ENVIRONMENTAL REVIEW COMMITTEE REPORT

ERC MEETING DATE:	August 30, 2010		
Project Name:	109 Logan Ave. Mixed Use		
Owner:	Amrik Kamoh & Angie Singh, 13955 Interurban Avenue South, Tukwila, WA 98168		
Applicant:	Same as above		
Contact:	Torjan Ronhovde, The Ronhovde Architects, LLC, 14900 Interurban Avenue South, #138, Tukwila, WA 98168		
File Number:	LUA10-047, ECF, SA-A		
Project Manager:	Gerald Wasser, Associate Planner		
Project Summary:	The applicant is requesting Environmental (SEPA) Review and Administrative Site Plan Review for the development of a mixed use project in the CD Zone. The project would include two 3-story buildings (36-40 feet in height) on an existing 10,000 s.f. site. The proposed buildings would have ten residential units (five in each structure), and 2,422 s.f. of ground floor commercial space. Parking would be accommodated in under-building and partially covered parking areas. Residential density would be 52.63 du/ac. Access to the site would be via a new 20-foot wide driveway from Logan Ave South. The project site is flat and grading is expected to be less than 500 cubic yards of export from the site.

109 LOGAN MIXED USE

EXHIBIT 4

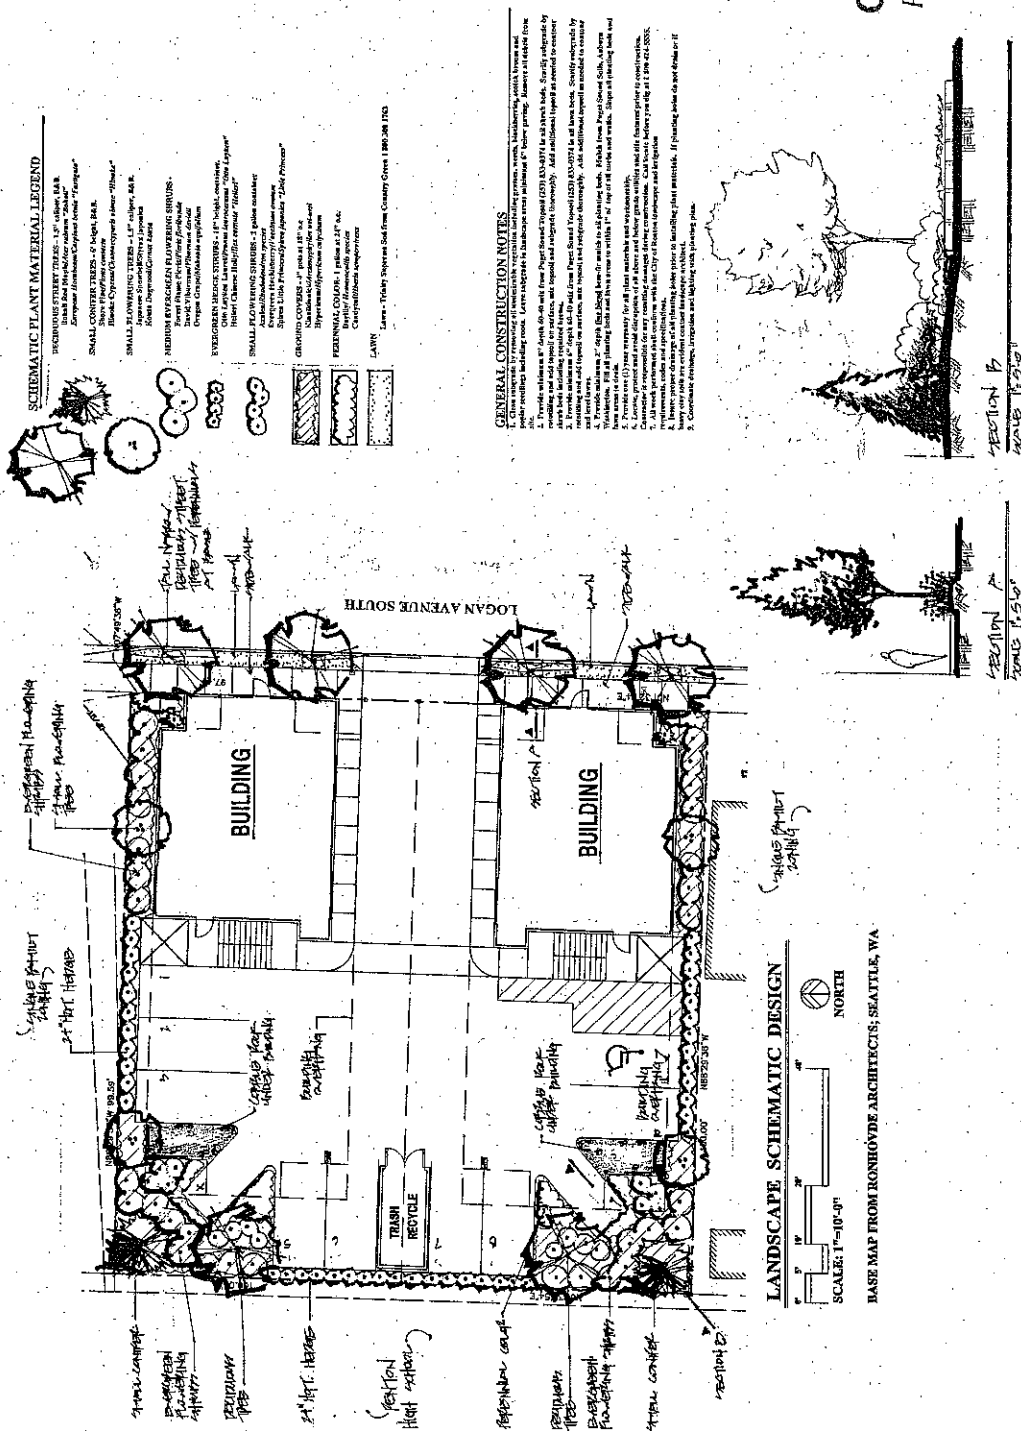
2. Planting strip is 3-feet wide, Code requires a minimum of 6-feet for this type of street.
3. Because planting strip width is very narrow use only small-maturing deciduous trees with an upright habit.

4. Planter strip shall contain a minimum of 3-feet of topsoil.
5. The Parks Department recommends that the number of street trees be reduced from 4 to 2.
